August 3, 1984

HOPE CREEK GENERATING STATION  
DOCKET NO. 50-354  
DRAFT SAFETY EVALUATION REPORT  
OPEN ITEM STATUS

In addition, enclosed for your review and approval (see Attachment 4) are the resolutions to the Draft SER open items, FSAR question responses and structural geotechnical audit item responses, listed in Attachment 3.

FIGURE A-13-11

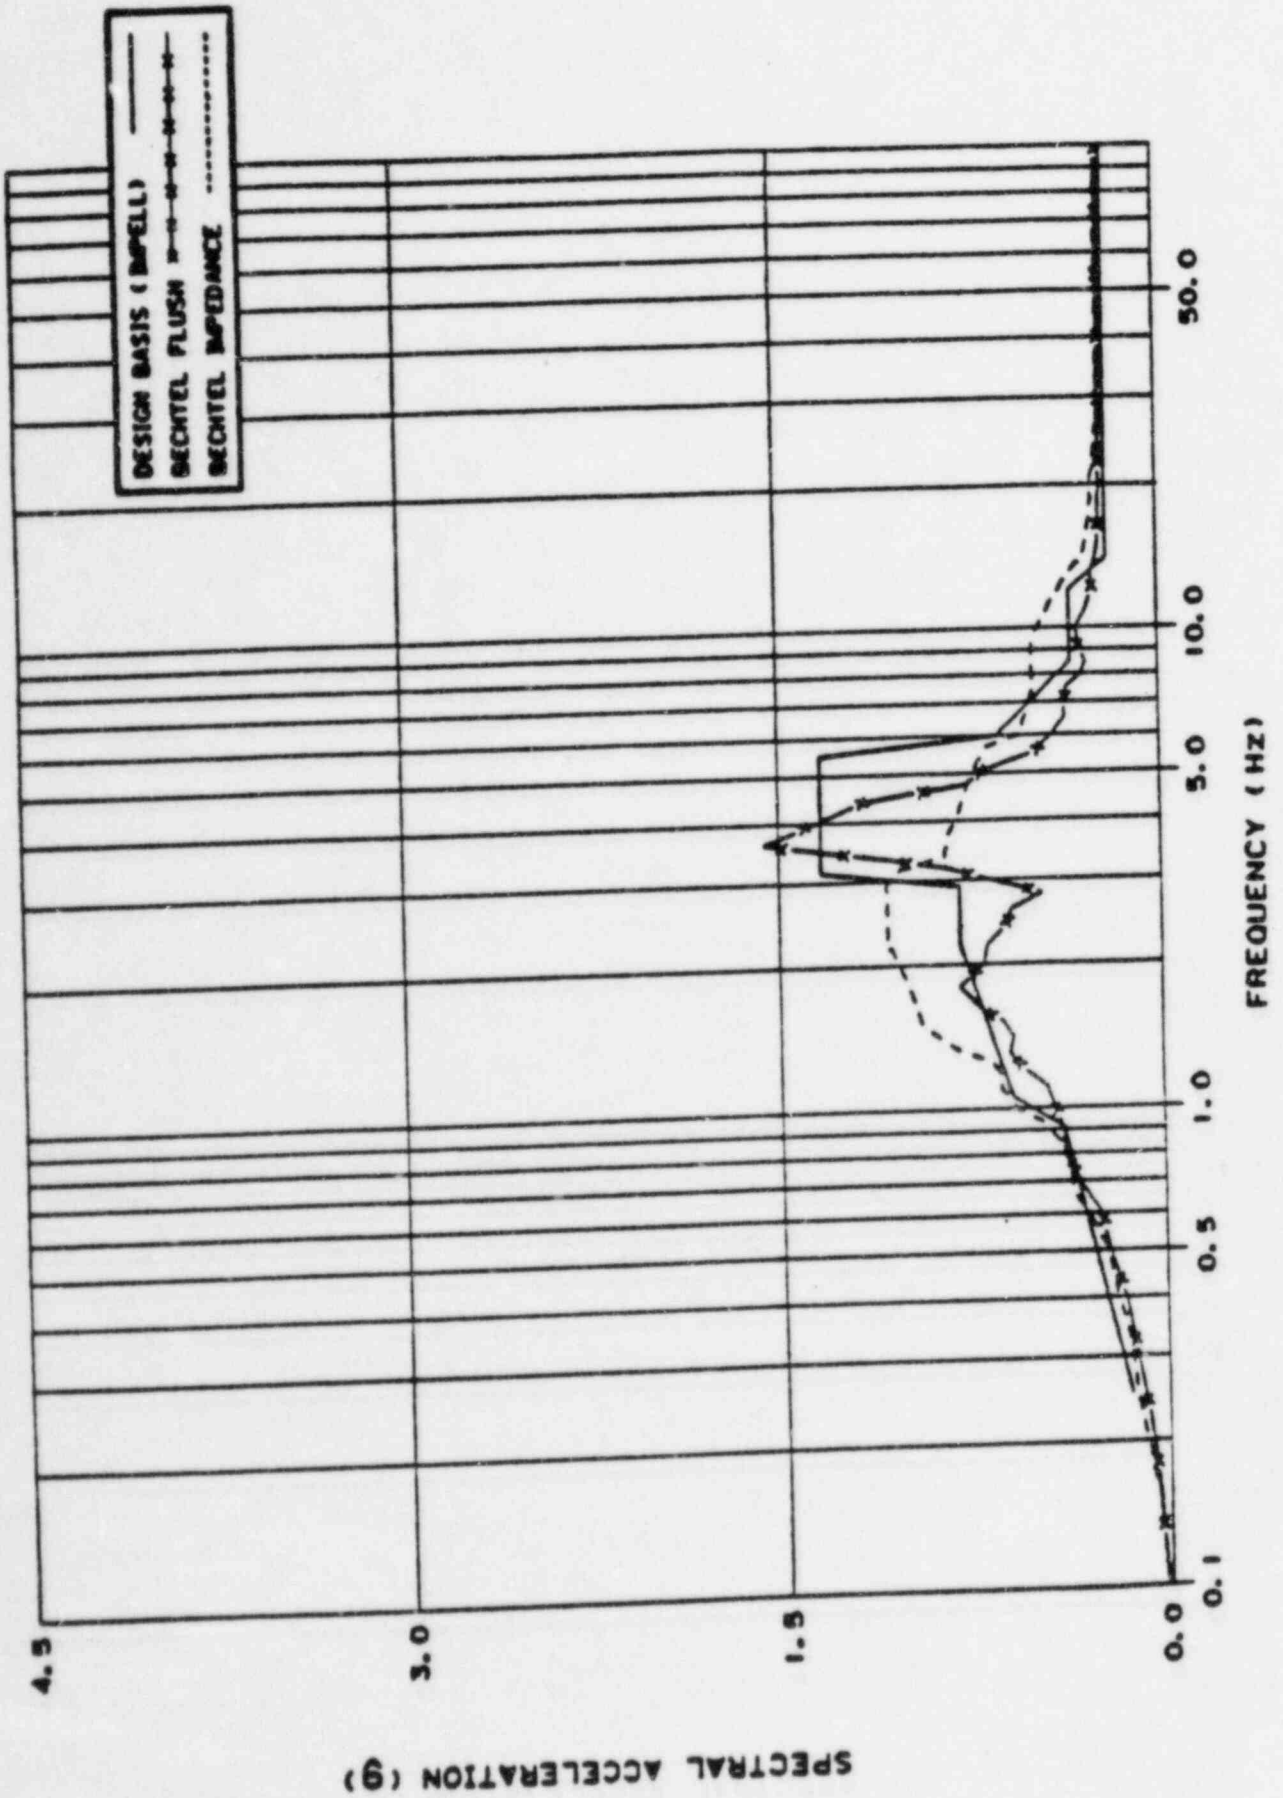
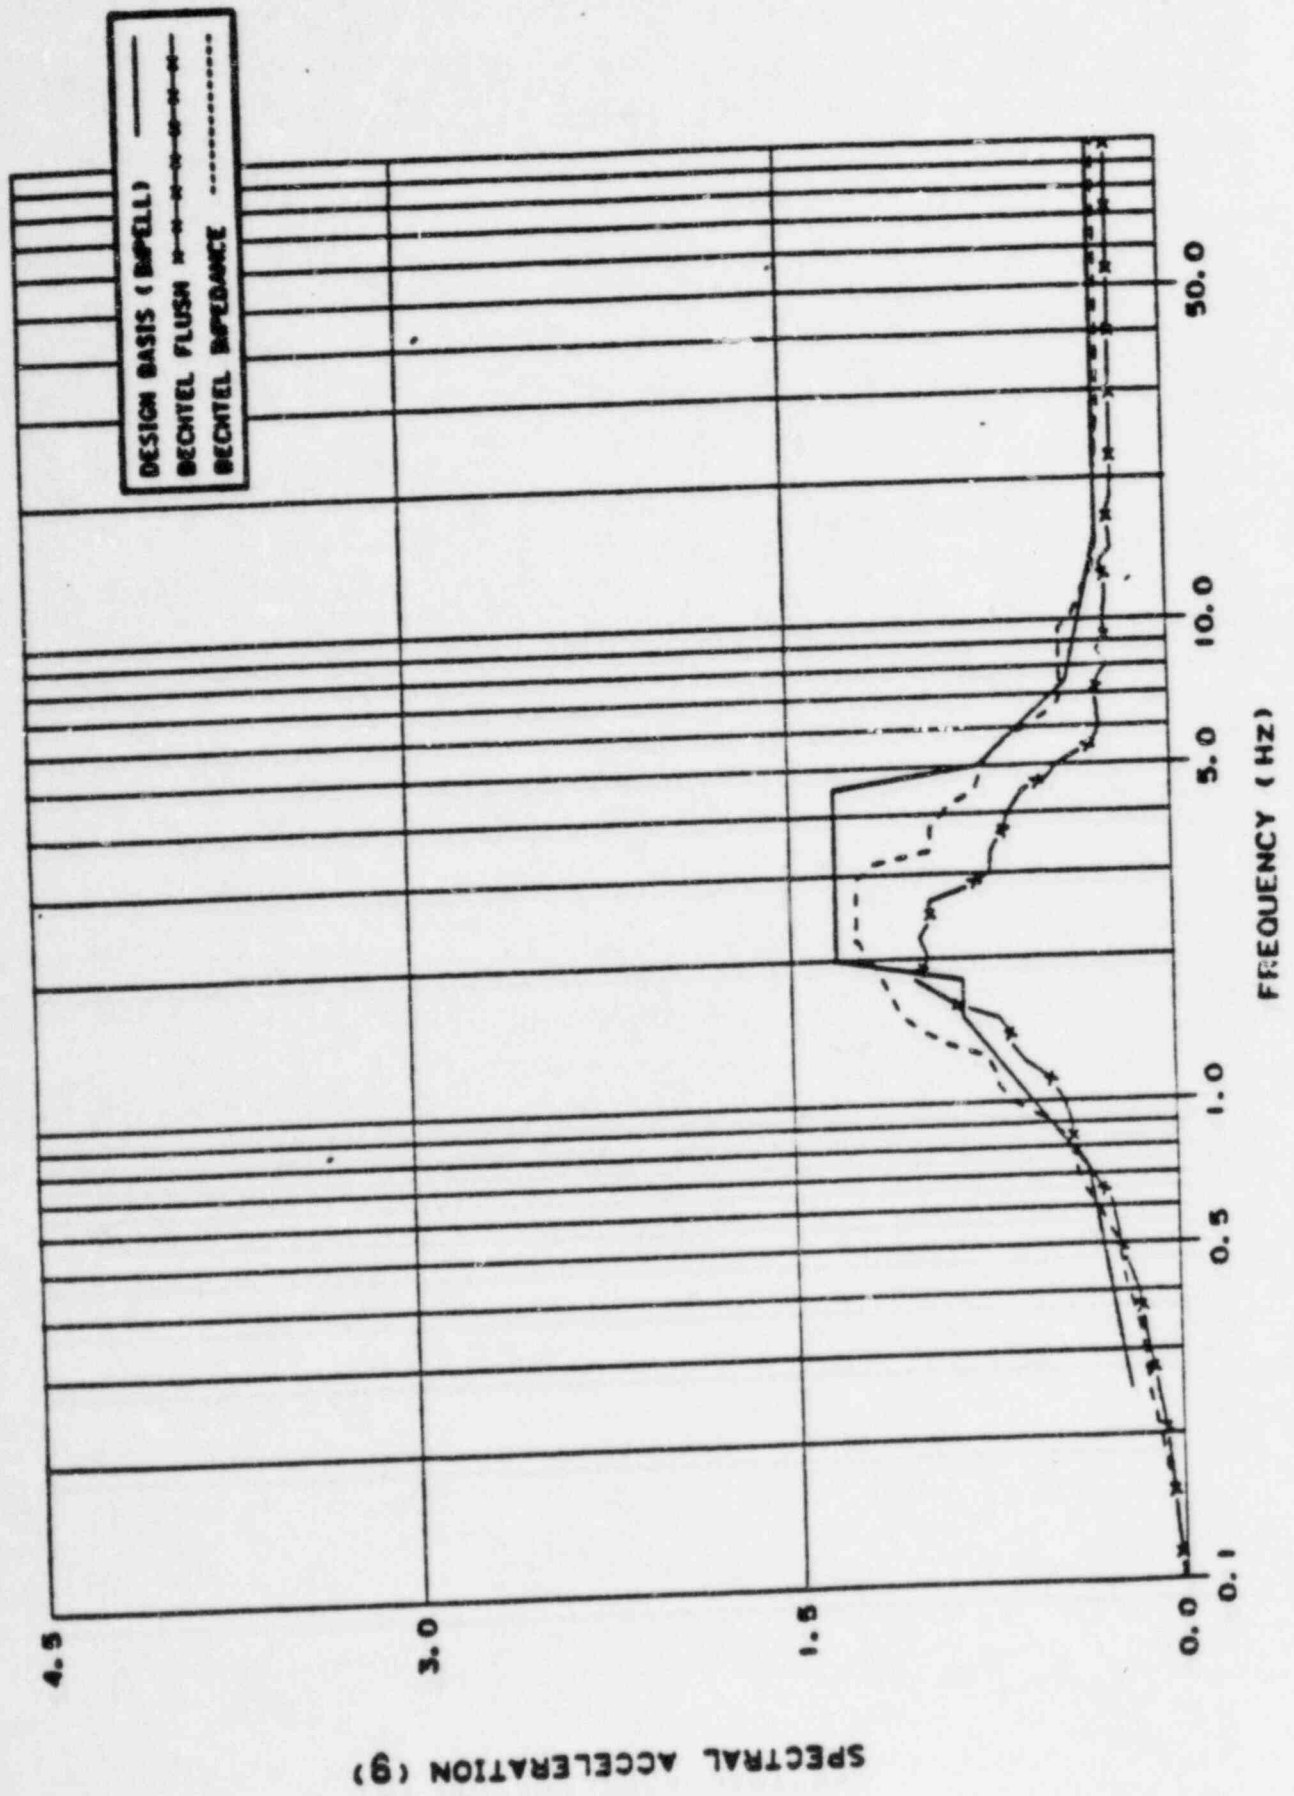
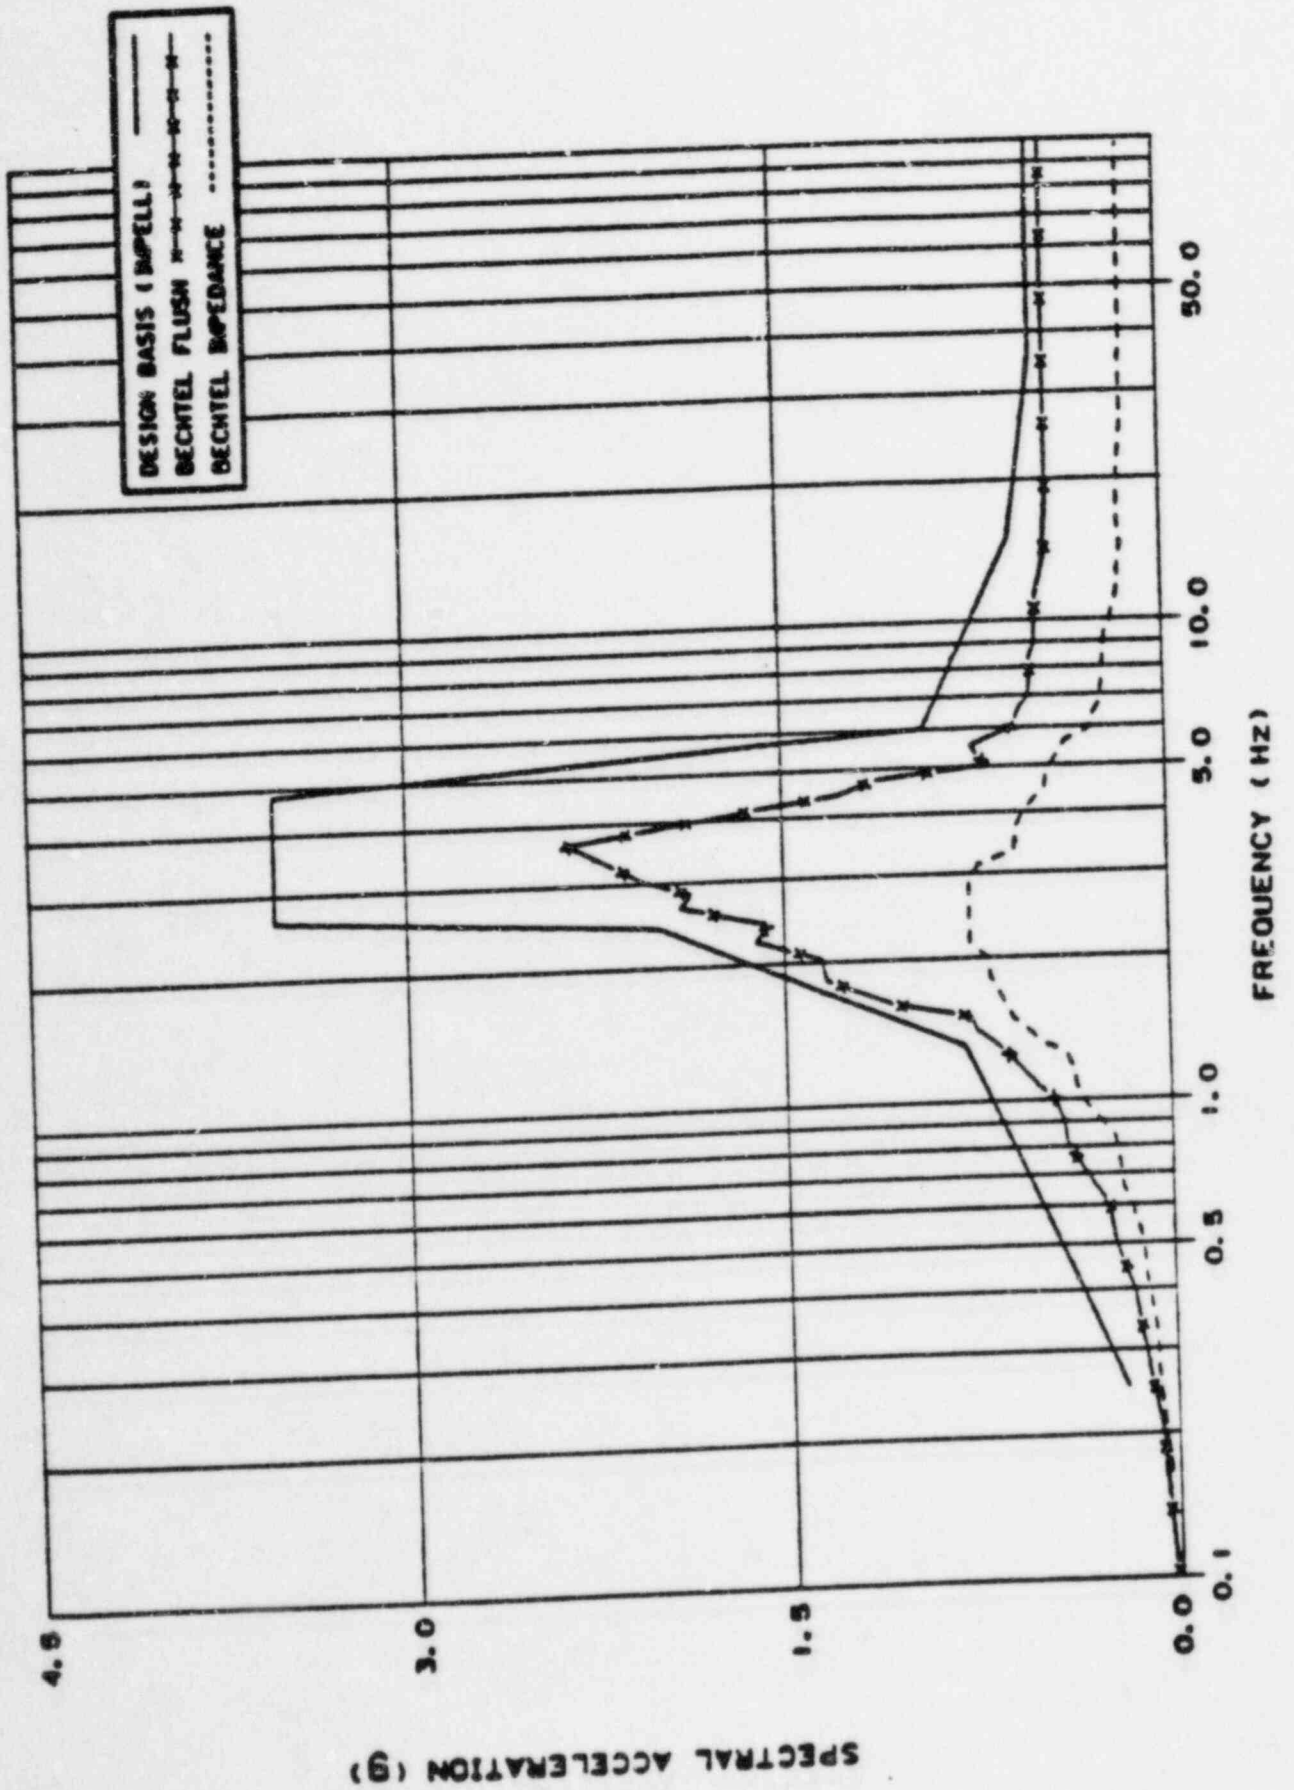
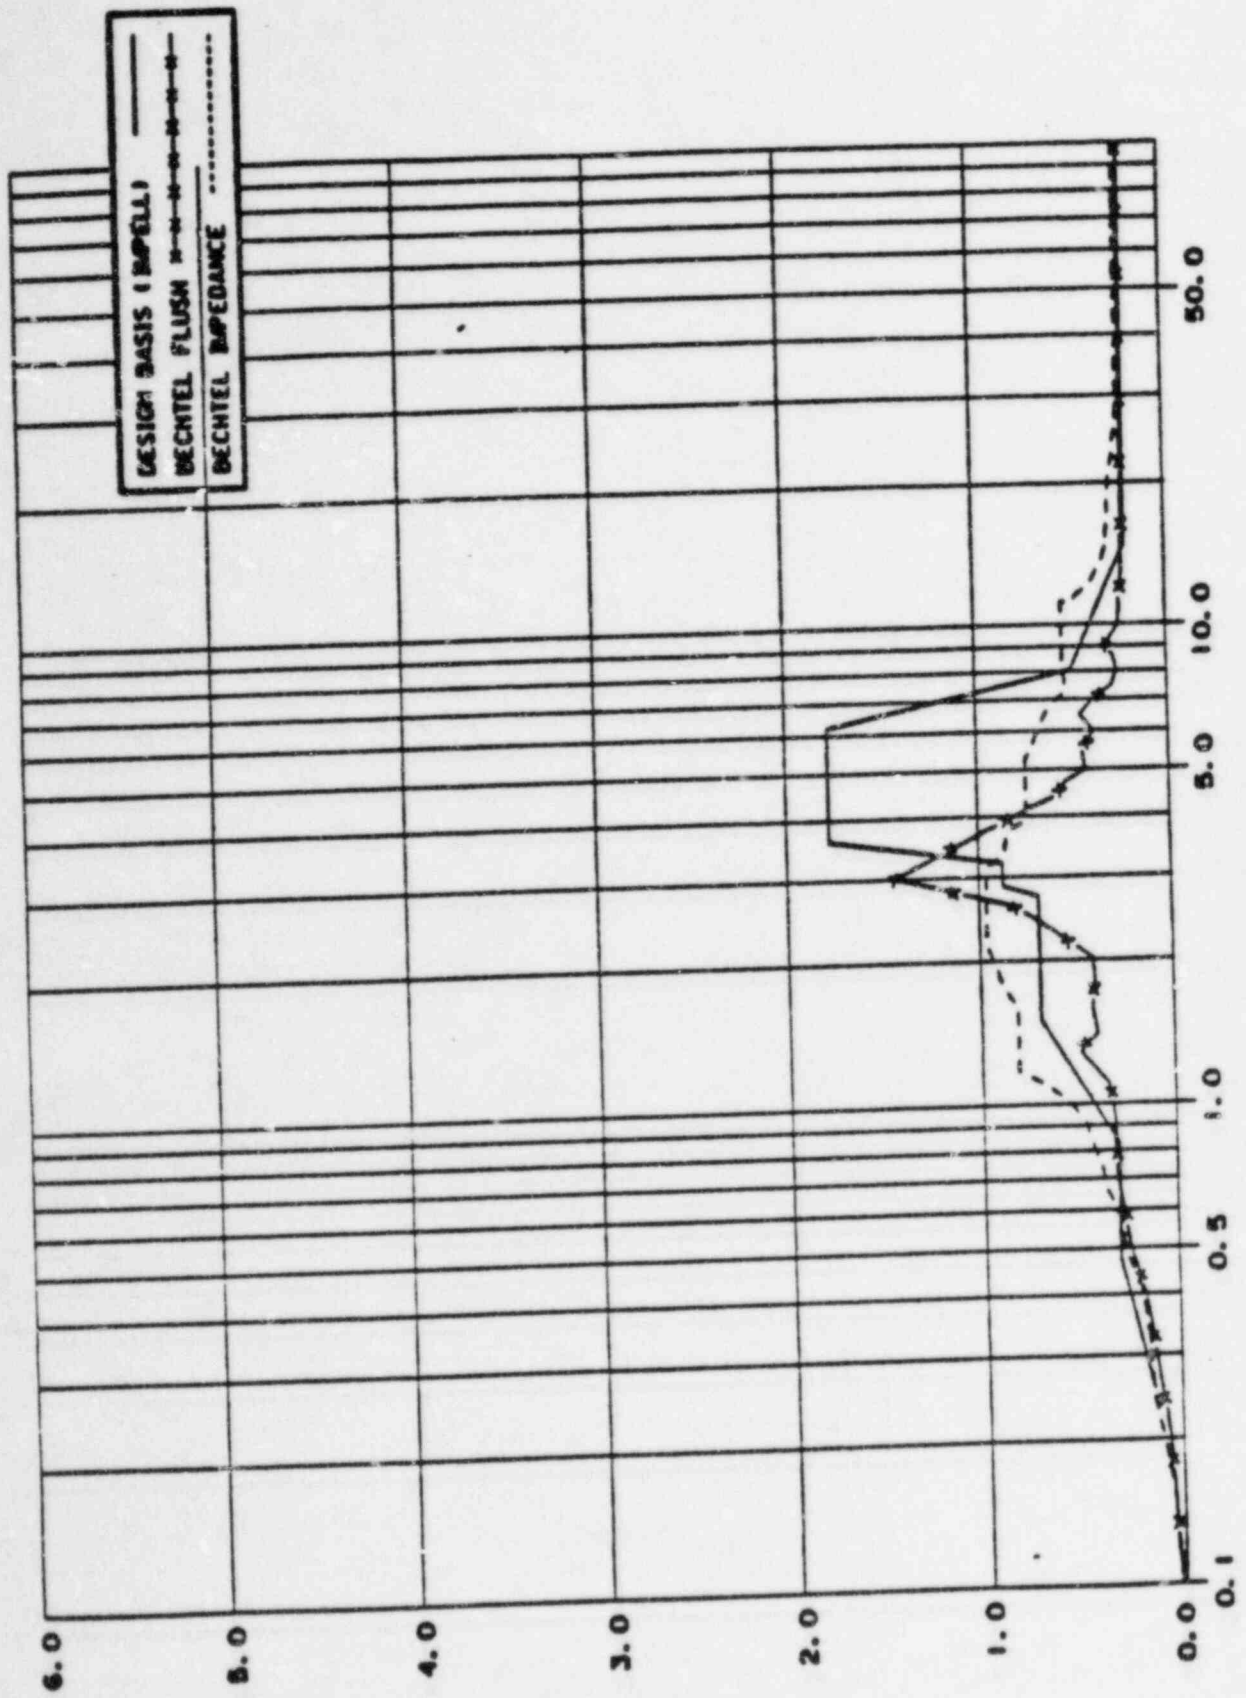
Question: Provide comparison of Bechtel Independent Verification Results with the Design Basis Results.

Figures A-13-2 to A-13-37 show the comparison of the response spectra (2% damping) obtained from the above three seismic soil-structure interaction analyses. Discussions of these comparisons are as follows:

Bechtel's independent soil-structure interaction analyses are performed using the computer code FLUSH. The results of independent finite element analyses are in reasonable agreement with those of the design basis analyses. As can be seen from Figures A-13-2 through A-13-37, the horizontal response spectra obtained from the independent finite element analyses are generally enveloped by those obtained from the design basis analyses except for the frequency range lower than 2 Hz. The vertical response spectra showed some exceedances at the frequency range of 18 Hz. These exceedances are listed in Table A-13-1.

The peak spectral accelerations obtained from the impedance approach analyses are generally lower than those obtained from the design basis analyses. However, these response spectra are not completely enveloped by those obtained from the design basis analysis, especially in the frequency range between 1.0 and 3.5 Hz. Also, there are some local exceedances in the higher frequency range, as shown in Figures A-13-2 through A-13-37.
